**Planning Department  
Transportation Development Services**

**Re: A-Class Storage on 2<sup>nd</sup> Street, 5124 Second Street  
Traffic Circulation Layout**  
Engineer's Stamp dated 12-01-14 (F15-D052B)

|                                | <b>TRAFFIC CIRCULATION PLAN</b>   | <b>DATE 12-1-14</b> |

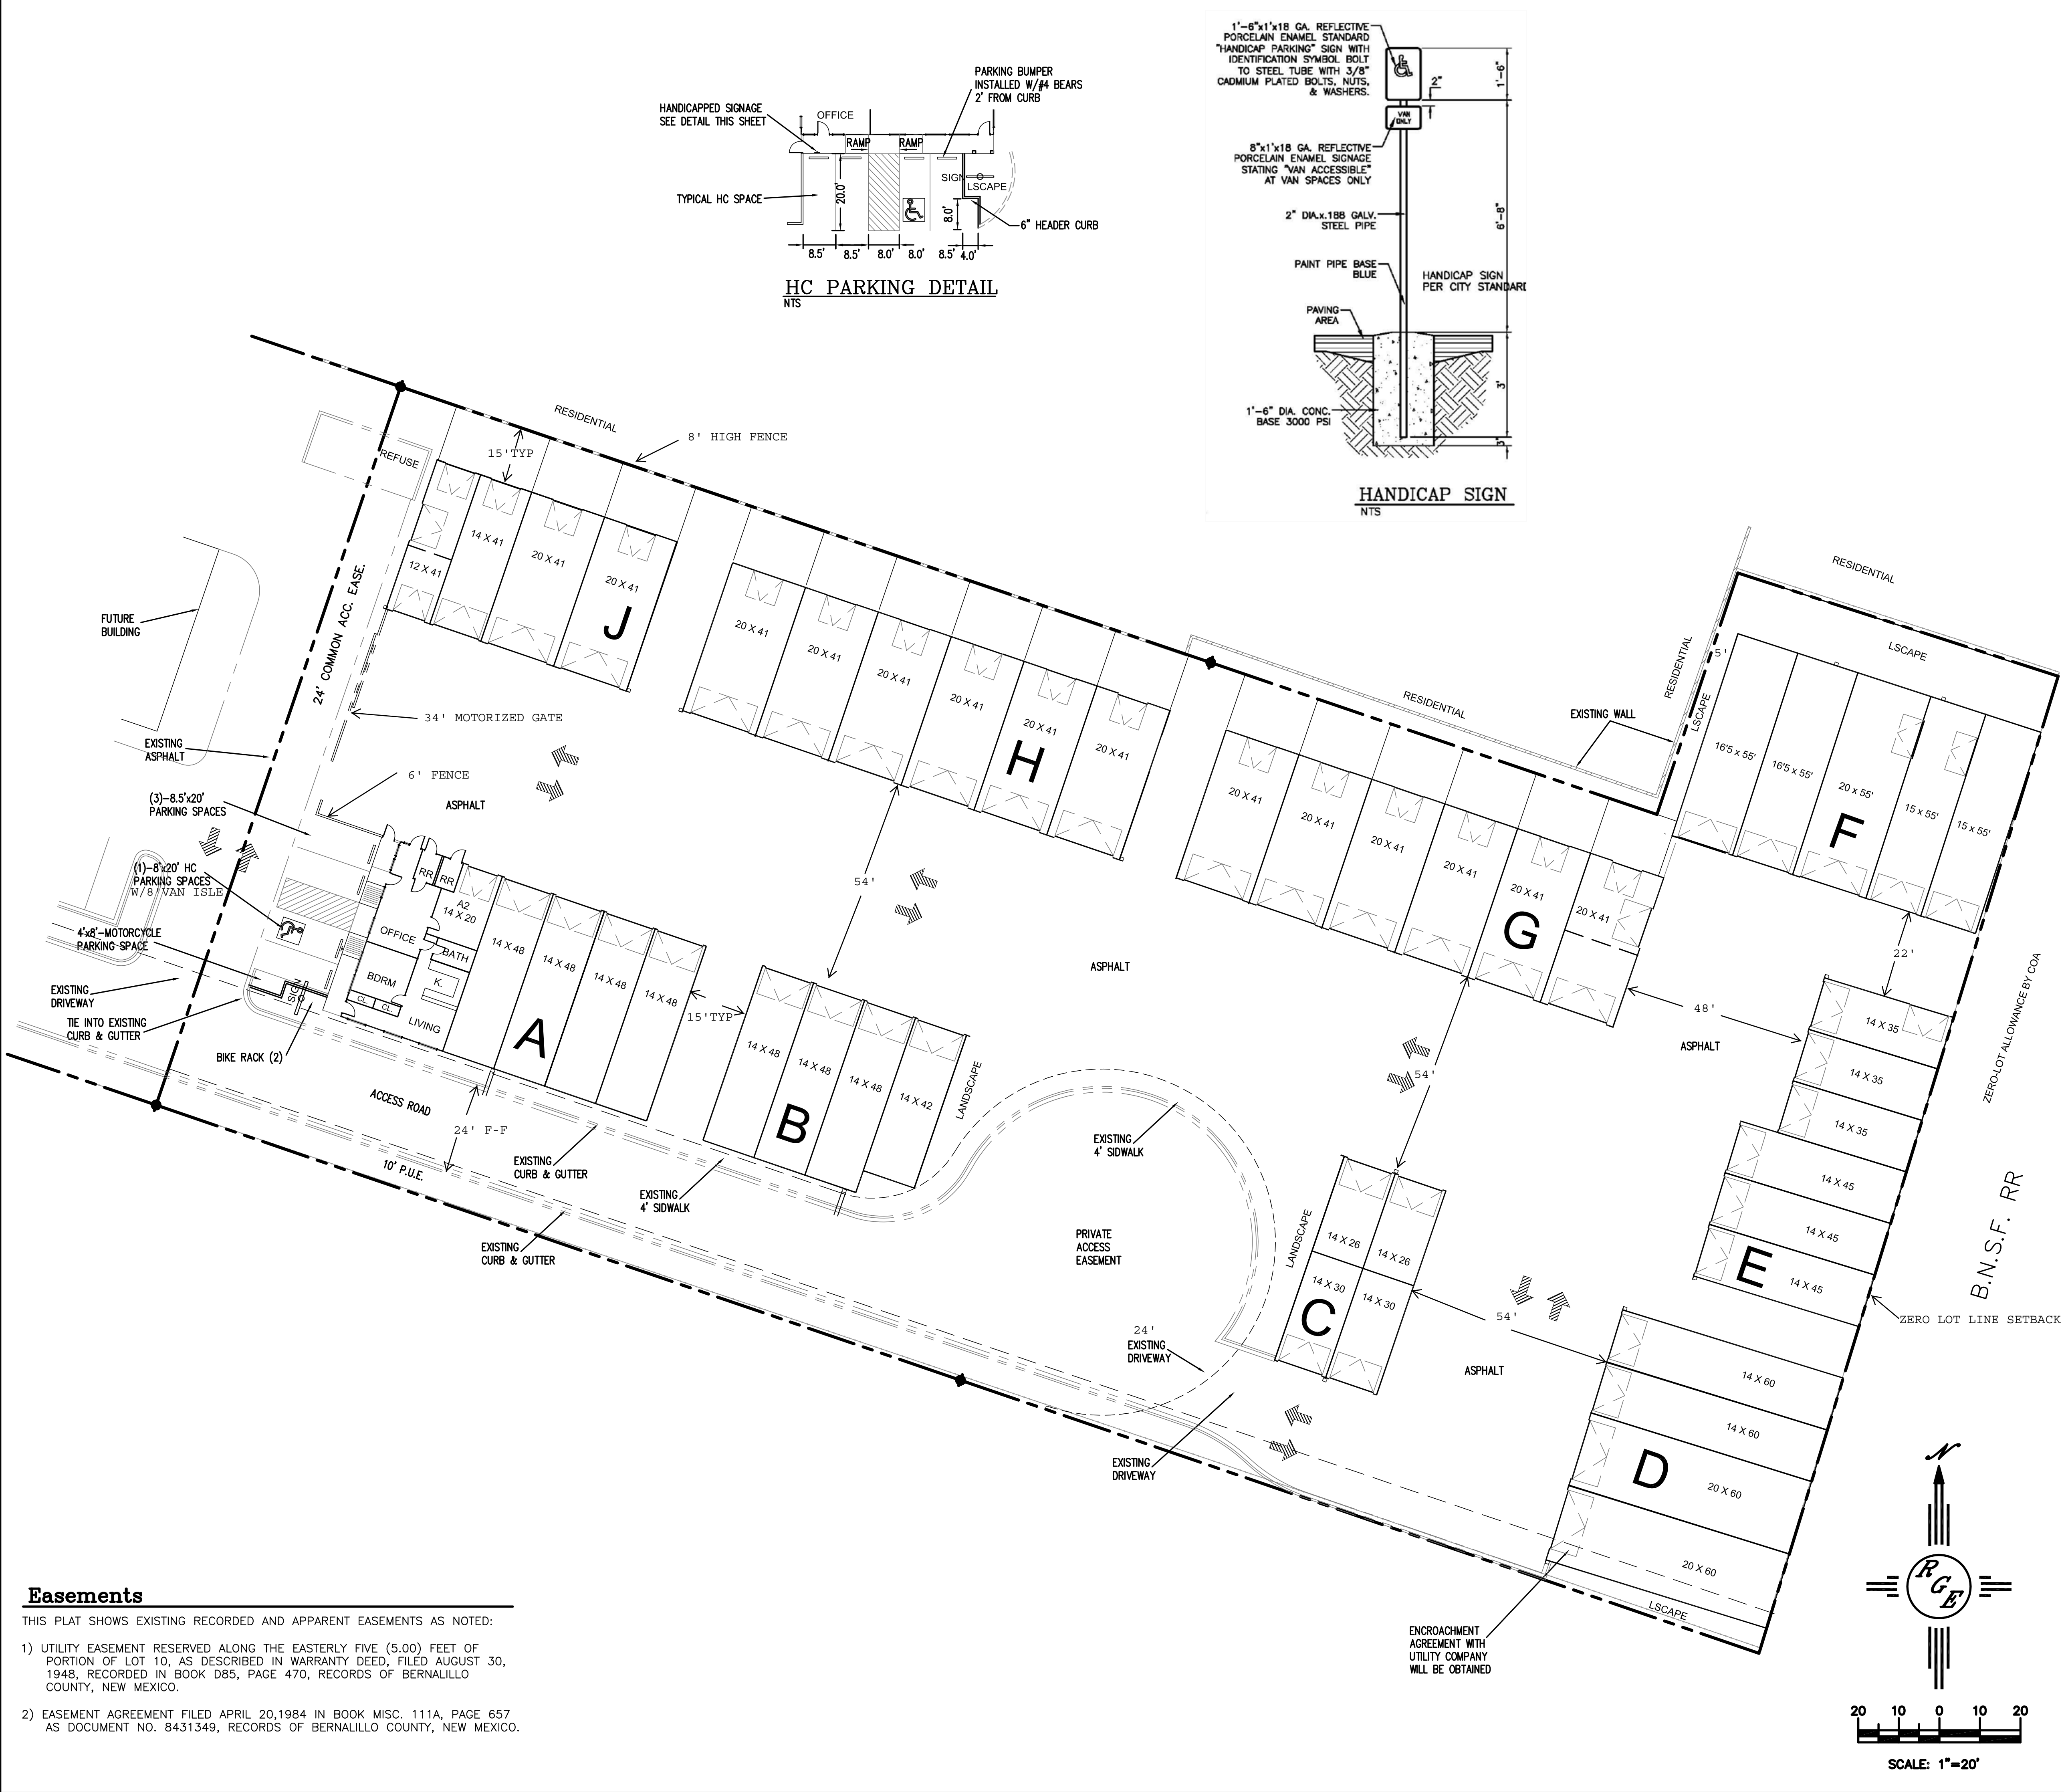
1. On the vicinity map, legibly call out the site location. Also, provide the site address on the plan.
2. Identify the access road easement width for the access road south of the site.

3. The dimensioning for the asphalt access through the site needs to be shown correctly for "54' " and "48' " dimensions. Call out edge of new asphalt, and provide pavement section for the asphalt drive.

4. Show both the north and south limit of the 34-foot motorized gate at the site entrance.
5. The ADA van accessible sign must have the required language per 66-7-352.4C NMSA 1978 **"Violators Are Subject to a Fine and/or Towing."** Call out the handicapped signage at the location of the handicapped space within the detail.

6. The ADA access aisle shall have the words **"NO PARKING"** in capital letters, each of which shall be at least one foot high and at least two inches wide, placed at the rear of the parking space so as to be close to where an adjacent vehicle's rear tire would be placed. (66-1-4.1.B NMSA 1978)

7. Per the DPM, a 6 ft. wide ADA accessible pedestrian pathway is required from the public sidewalk and from the HC parking stall access aisle to the building entrances. Call out the width of the sidewalk adjacent to the building as a minimum of 6 feet, and tie this sidewalk to the existing sidewalk on the access

8. Call out curb height for the curb along the handicapped parking spaces.
9. At both the 24-foot common access easement and at the intersection of the common access easement with the access road, there might be a sight distance issue. Provide a mini-clear site triangle (per page 23-28 of the DPM) at both of these sight locations. What type of 6-foot high fence is being installed near the motorized gate, and will it interfere with sight distance? Add the following note to the clear sight triangles: "Landscaping and signage will not interfere with clear sight requirements. Therefore, signs, walls, trees, and shrubbery between 3 and 8 feet tall (as measured from the gutter pan) will not be acceptable in this area."
